Sydney Metro request a modification to Conditions D26 and D122 of the Sydney Metro West Westmead to The Bays and Sydney CBD (Concept and Stage 1) project approval (SSI_10038) in accordance with the requirements of section 5.25 of the *Environmental Planning and Assessment Act 1979* (EP&A Act).

Table 1: Request for Modification

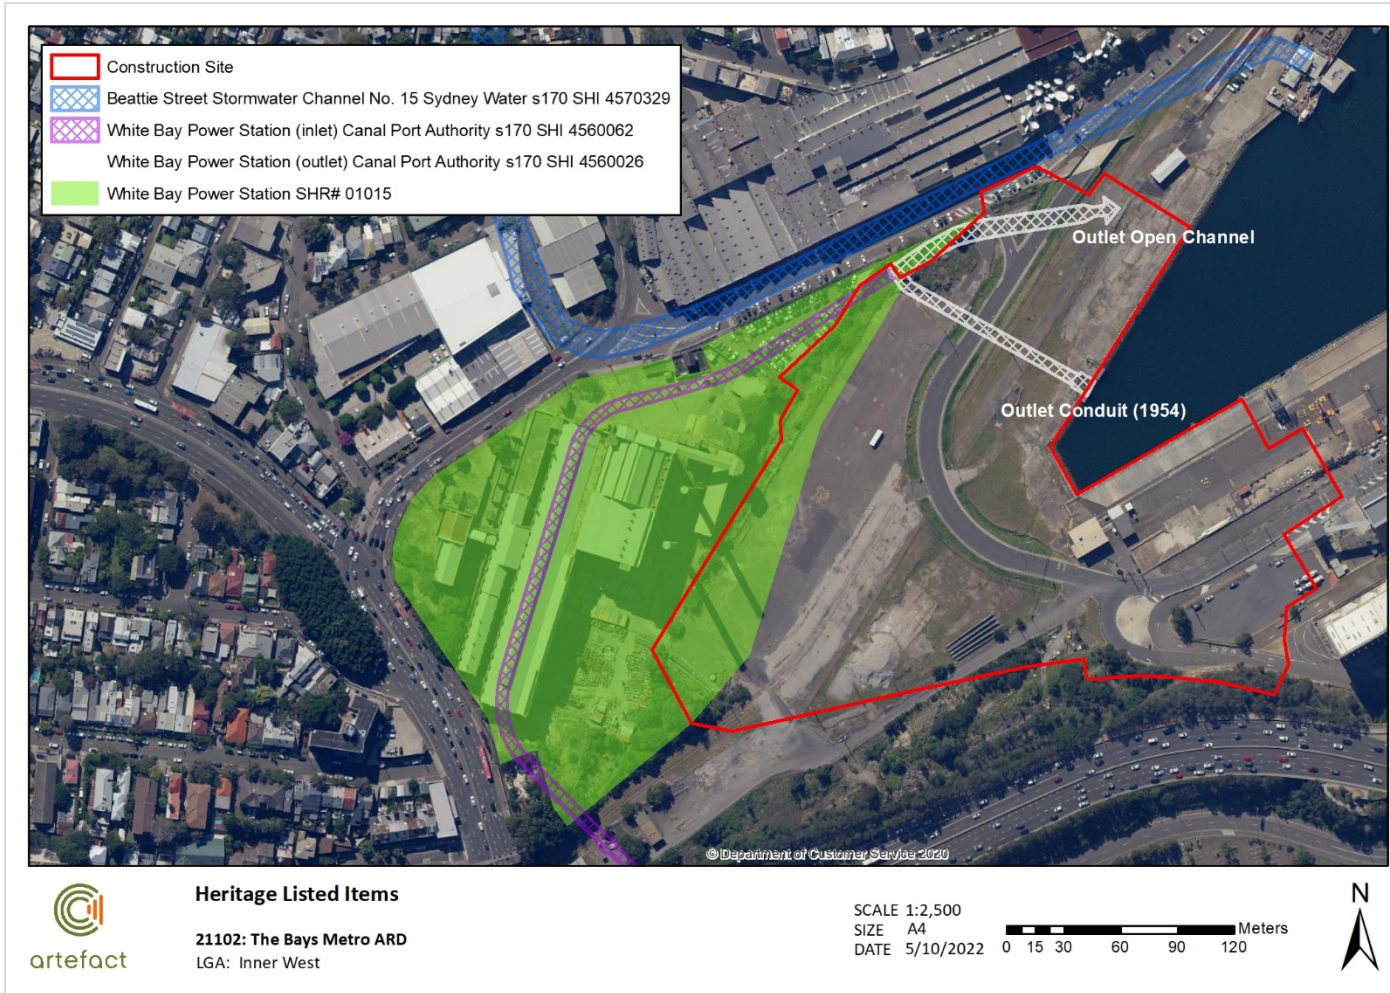
CoA	Condition of Approval	Proposed revised wording	Justification for proposed modification to conditions
D26	The revised Archaeological Research Design and Excavation Methodology(s) must include provision for early physical investigation of areas of impact identified as likely to contain State significant archaeology or subterranean Heritage items in the research design to inform excavation in these areas. This must include the Parramatta and The Bays metro station sites, including Parramatta Convict Drain, Parramatta Sand Body, White Bay Power Station (inlet) Canal and Beattie Street Stormwater Channel.	The revised Archaeological Research Design and Excavation Methodology(s) must include provision for early physical investigation of areas of impact identified as likely to contain State significant archaeology or subterranean Heritage items in the research design to inform excavation in these areas. This must include the Parramatta and The Bays metro station sites, including Parramatta Convict Drain, Parramatta Sand Body, White Bay Power Station (intet outlet) Canal and Beattie Street Stormwater Channel.	<p>The White Bay Power Station (inlet canal) (Port Authority of NSW s170 4560062) is incorrectly identified in the</p> <ul style="list-style-type: none"> Westmead to The Bays and Sydney CBD. Concept and Stage 1. Environmental Impact Statement including Technical Paper 3: Non-Aboriginal Heritage, Artefact 2020. Appendix F Response to Submissions Non-Aboriginal Archaeological Research Design, Artefact 2020 Sydney Metro West Power Enabling Works, The Bays Construction Site, Revised Historical Archaeological Research Design & Excavation Methodology, GML 2021. Sydney Metro West – Power Enabling Works Rozelle – Position Paper on the White Bay Power Station Circulating Water System, GML 2021 Sydney Metro West Power Enabling Works Rozelle – White Bay Power Station Circulating Water System – Heritage Impact Statement, GML 2021 Sydney Metro West, The Bays Power Enabling Works – Archaeological Assessment of New Conduit Alignment, GML 2022 Sydney Metro West Power Enabling Works, The Bays Station Construction Site, Historical Archaeological Test Excavation Report, GML 2022 Sydney Metro West, The Bays Power Enabling Works – Revised Inlet Canal Impact Assessment, GML 2022
